MONTGOMERY COUNTY PLANNING DEPARTMENT
THE MARYLAND-NATIONAL CAPITAL PARK AND PLANNING COMMISSION

REVIEW TYPE: Pre-Preliminary Plan Review per Section 50-33

PROJECT NAME: Ashton Manor
CASE #: 720060500
REVIEW BASIS: Chapter 50, Montgomery County Subdivision Regulations

PRE-PRELIMINARY SUBDIVISION PLAN

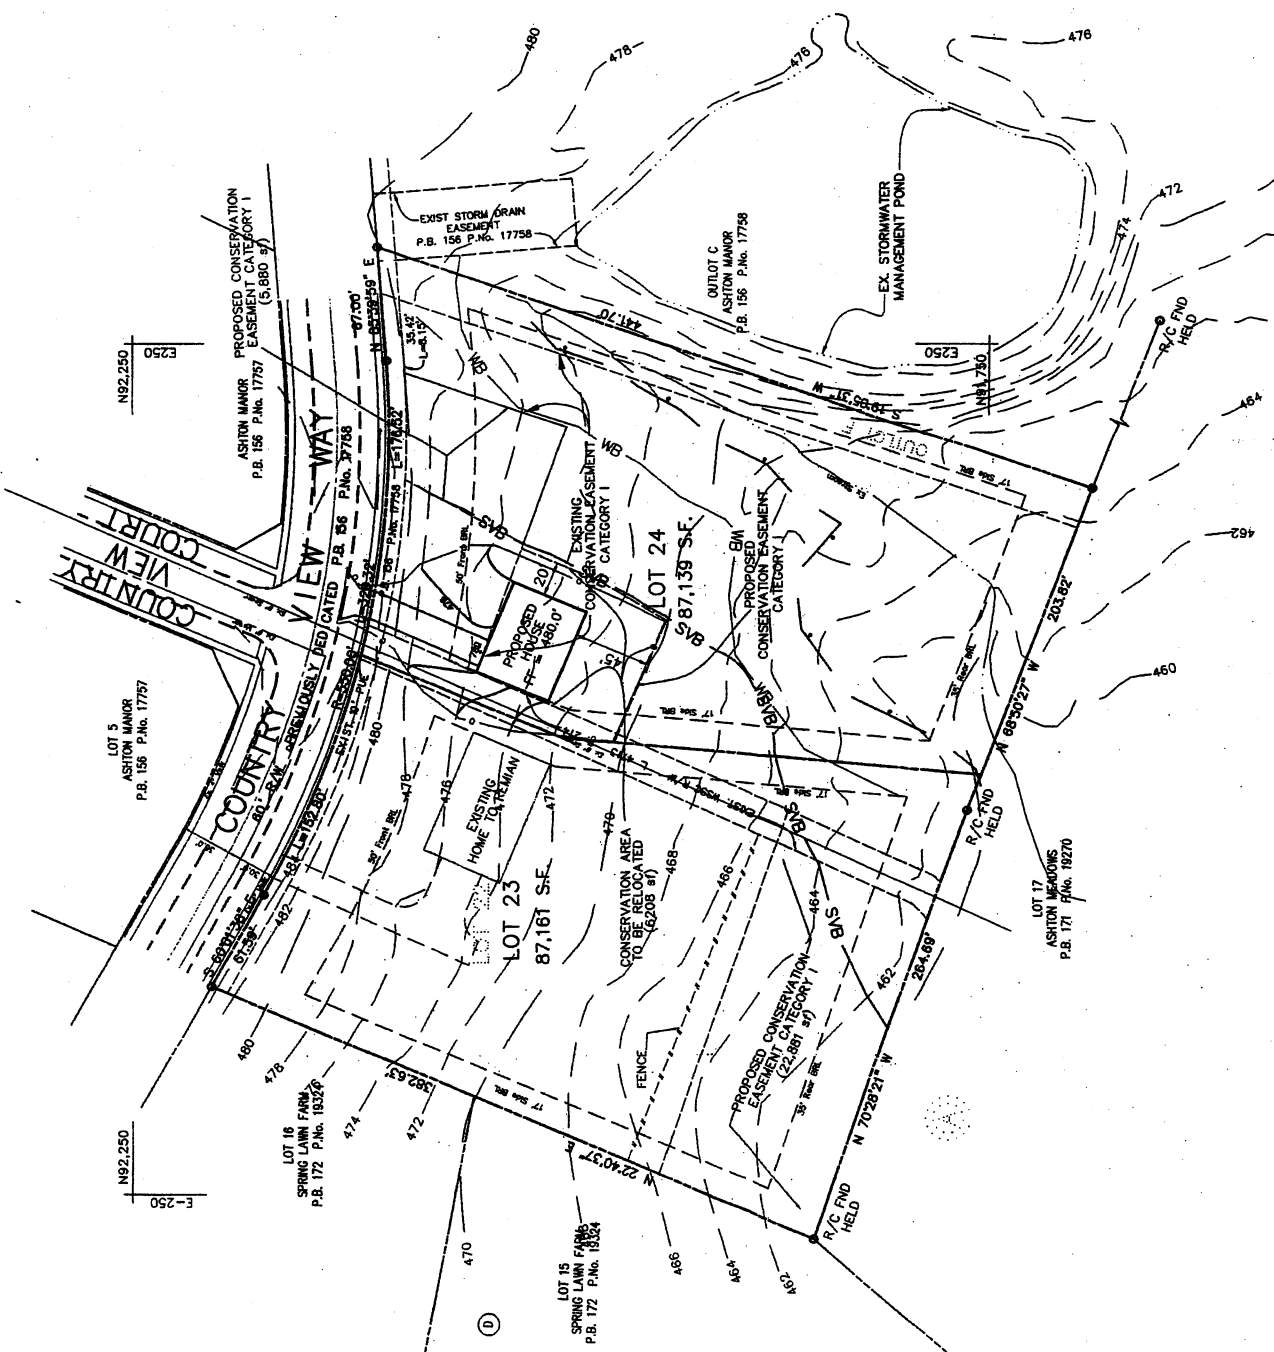
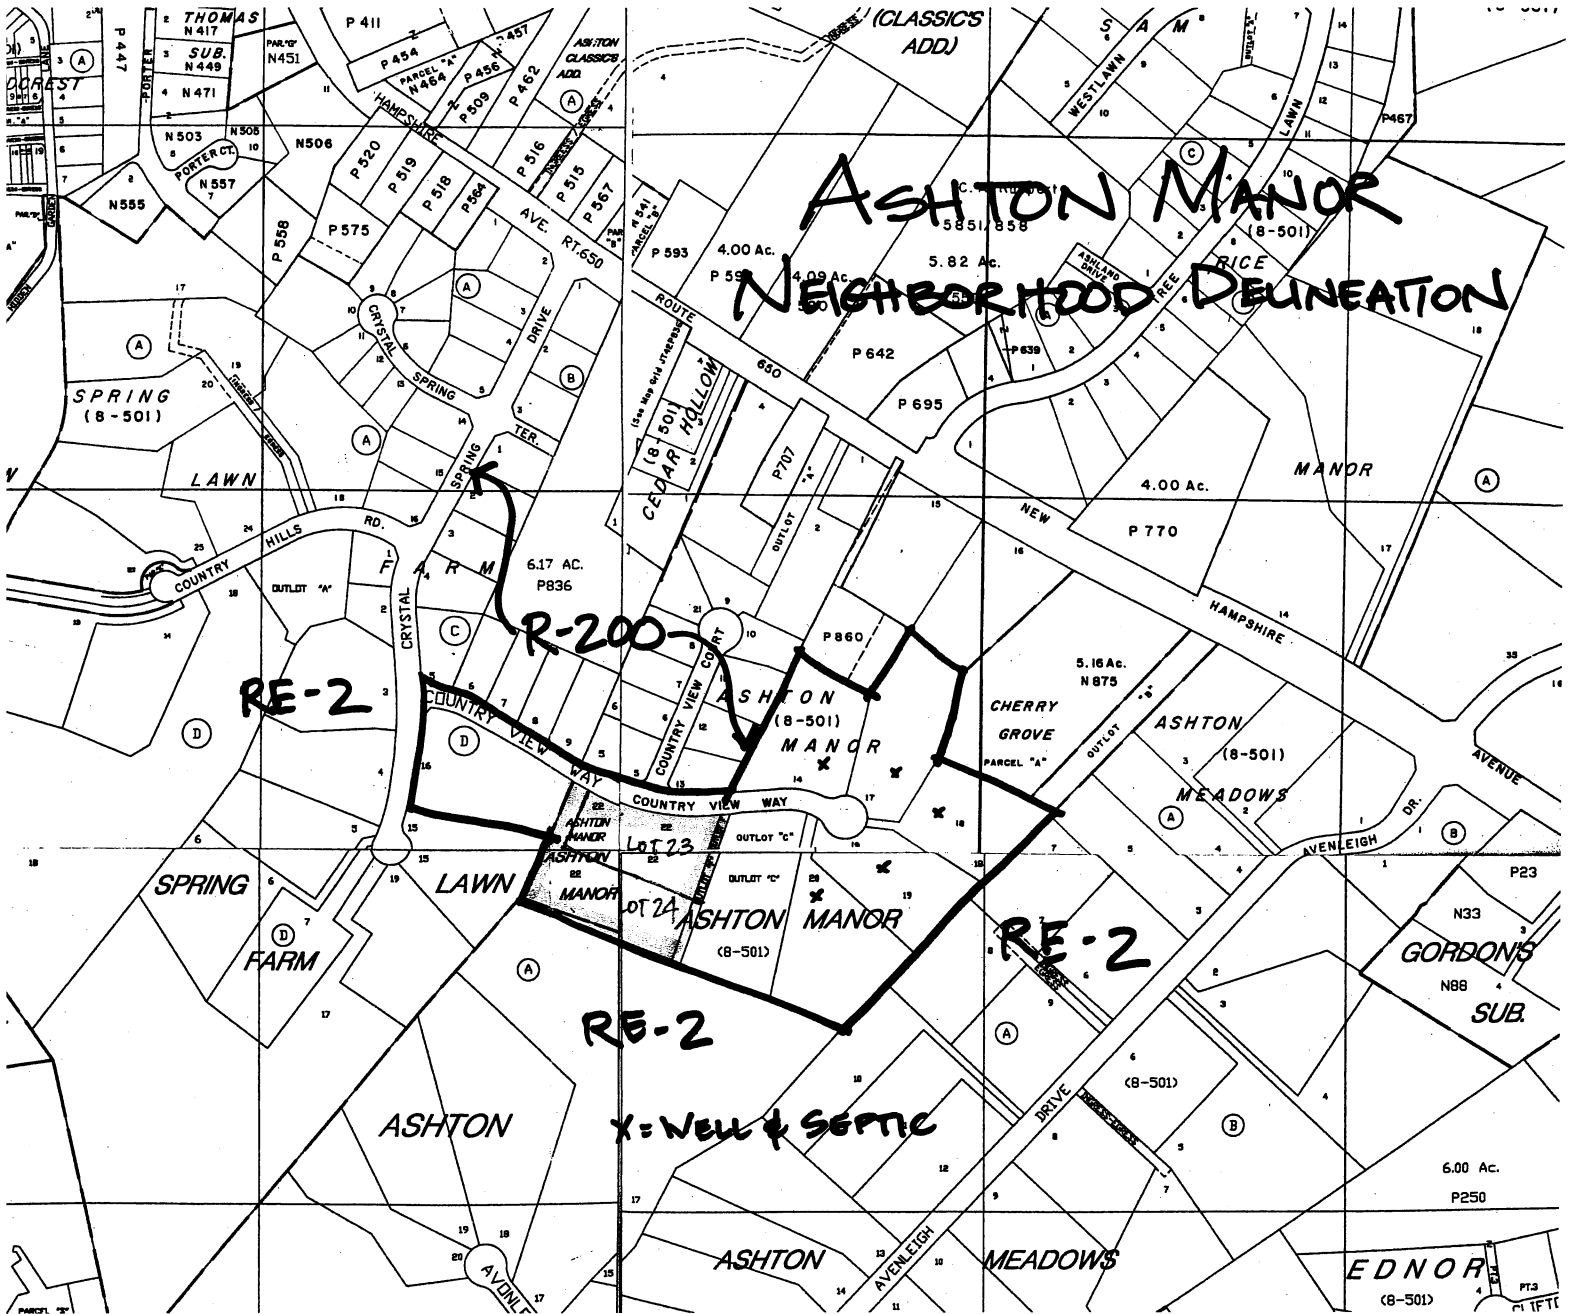
The site is covered by an approved forest conservation plan. The existing Category I conservation easement is mostly in the stream valley buffer. The proposed location for the house on proposed Lot 24 is, however, outside of the stream valley buffer. Further, a portion of the stream valley buffer that is not currently within the conservation easement will be protected by the reconfigured easement on proposed Lot 23.

It is staff's opinion that the proposed reconfiguration of the conservation easement is acceptable and consistent with the Forest Conservation Law because the entirety of the stream valley buffer onsite will be protected within the easement and there is a net gain in easement area of 0.77 acres, or a 53% increase in the size of the existing easement.

Area: In the six-lot neighborhood, buildable area ranges from 30,807 square feet to 65,158 square feet. Proposed Lot 23 has a buildable area of 40,650 square feet and proposed Lot 24 has a buildable area of 12,300 square feet. The buildable area of Lot 24 is greatly reduced because the lot is constrained with a large conservation easement that occupies the majority of the lot. Although the existing lot with smallest buildable area is

similarly constrained by a conservation easement, proposed Lot 24 has less than half the buildable area of the existing lot with the smallest area. **Therefore, the proposed lots would not be of the same character as other lots in the neighborhood with respect to buildable area.**

Section 50-29(b)(2) of the Subdivision Regulations specifies seven criteria with which resubdivided lots must comply. They are frontage, alignment, size, shape, width, area, and suitability for residential use within the existing block, neighborhood, or subdivision. As set forth above, proposed Lot 24 is not of the same character as the existing lots in the delineated neighborhood with respect to buildable area. Staff's evaluation indicates that the buildable area of the proposed lot is less than half the area of the existing lot with the smallest area. Therefore, the proposed resubdivision does not comply with Section 50-29(b)(2) of the Subdivision Regulations. As such, staff objects to the submission of the preliminary plan.
